CALIFORNIA CROSSROADS

Stage 2 Road Safety Audit

REPORT NUMBER: 70068199/RSA2/1/1

DATE: MARCH 2023

PROJECT NO: 70088199
 DRAWING NO: 8199-ATR-001
 DATE: May 2020
 REV: P05

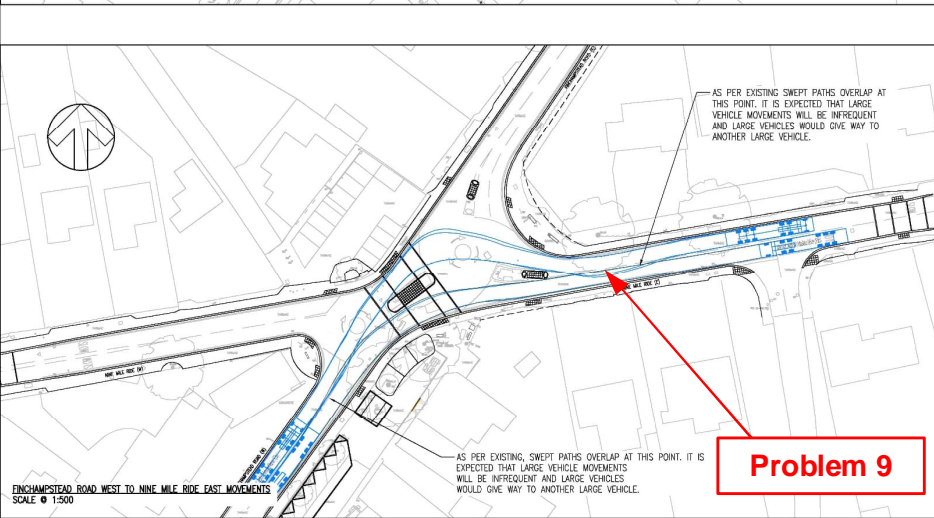
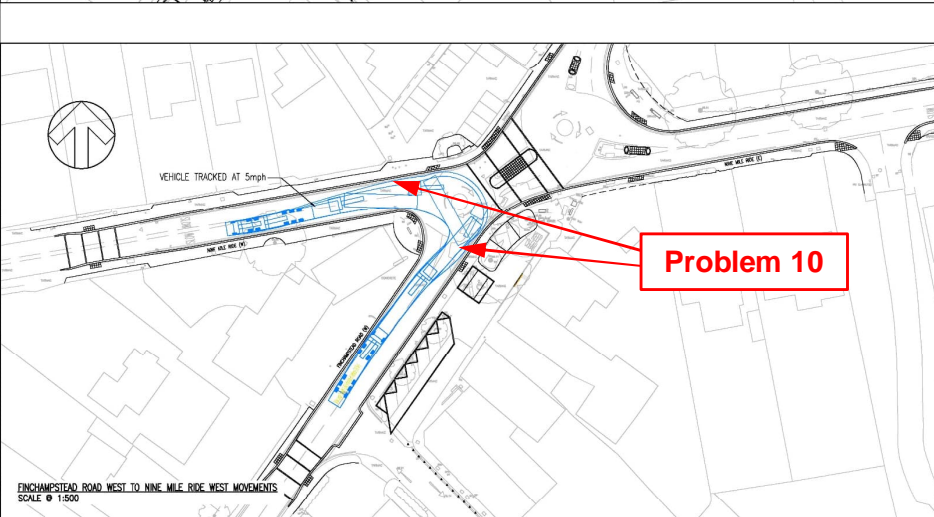
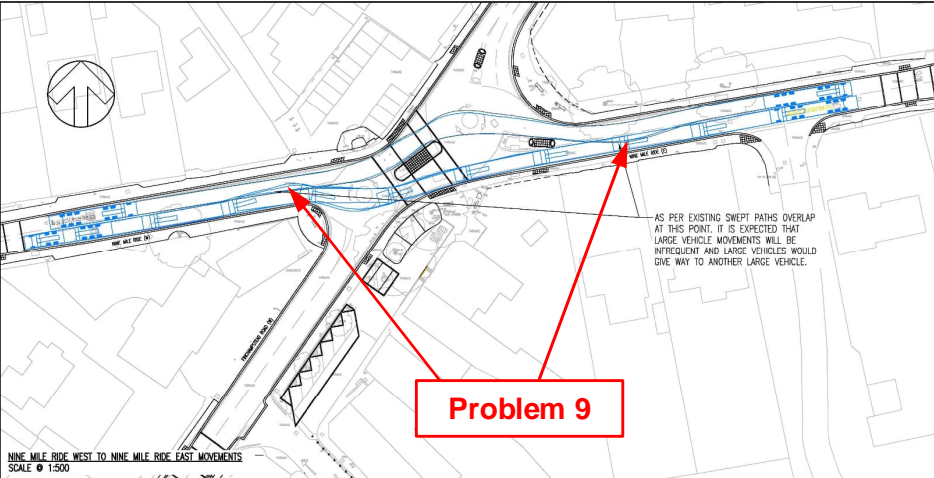
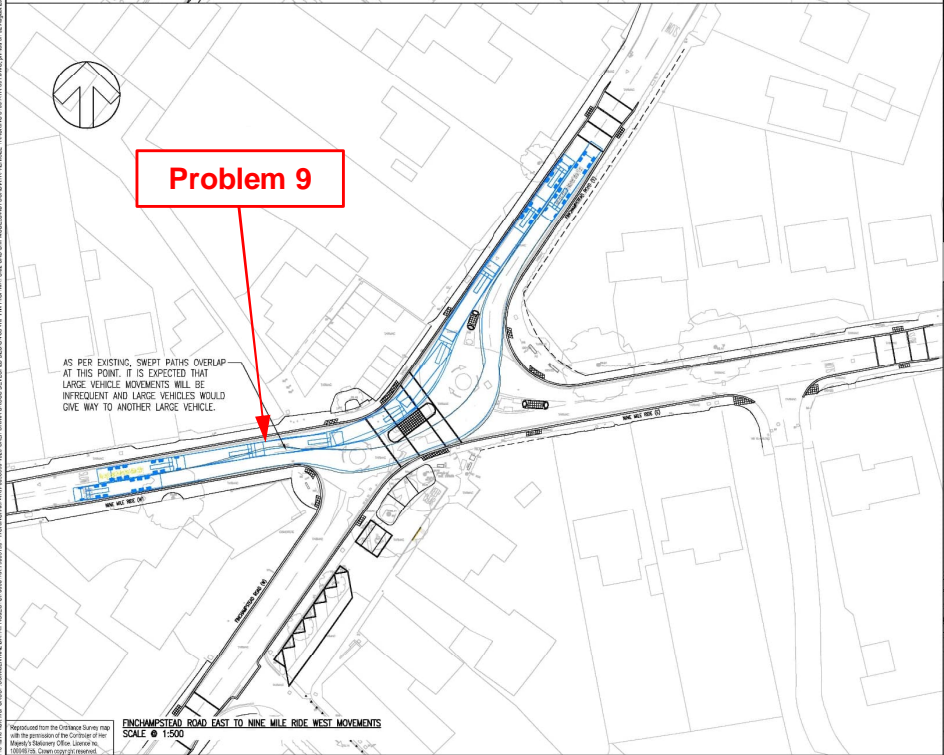
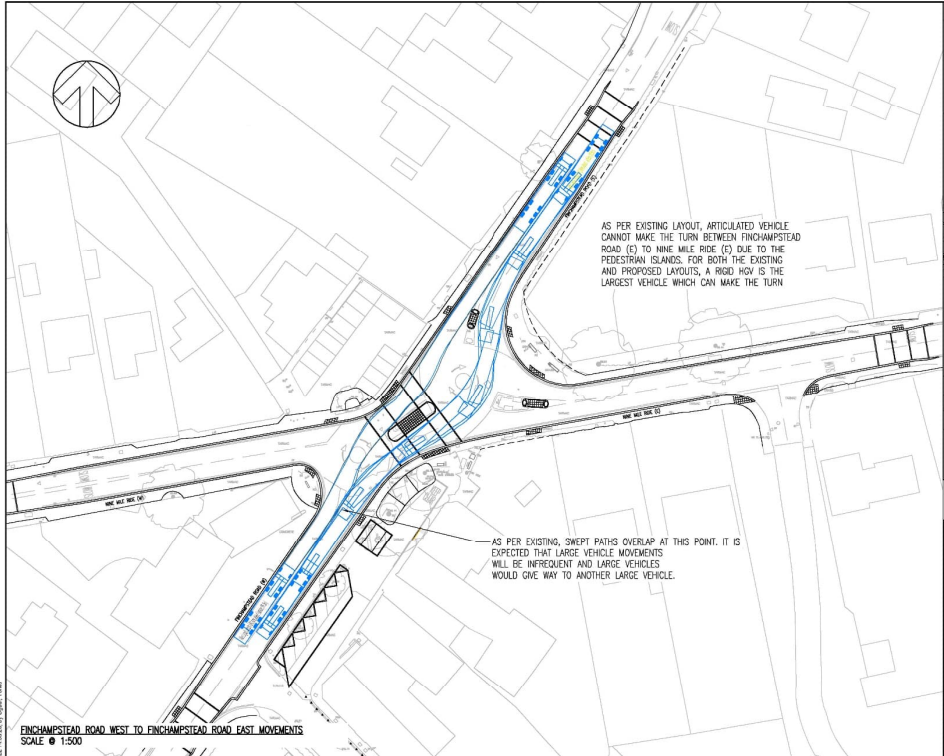
Drawing number 8199-ATR-001 (revision P05) shows the swept paths of 16.5m long articulated vehicles travelling through the proposed junction layout. Several vehicles of this type were observed travelling through the junction during the site visit. These heavy goods vehicles (HGVs) turning onto Nine Mile Ride, travelling westbound and eastbound, are shown to encroach into the opposing traffic lanes used by vehicles approaching the junction. This could increase the potential for a head-on collision between an HGV and a vehicle approaching the junction on Nine Mile Ride.

Drawing number 8199-ATR-001 (revision P05) shows the swept paths of 16.5m long articulated vehicles travelling through the proposed junction layout. These HGVs turning between Nine Mile Ride (West) and Finchampstead Road (South) in both directions will encroach notably into the path of opposing traffic on the approaches / exits at the junction on these arms.
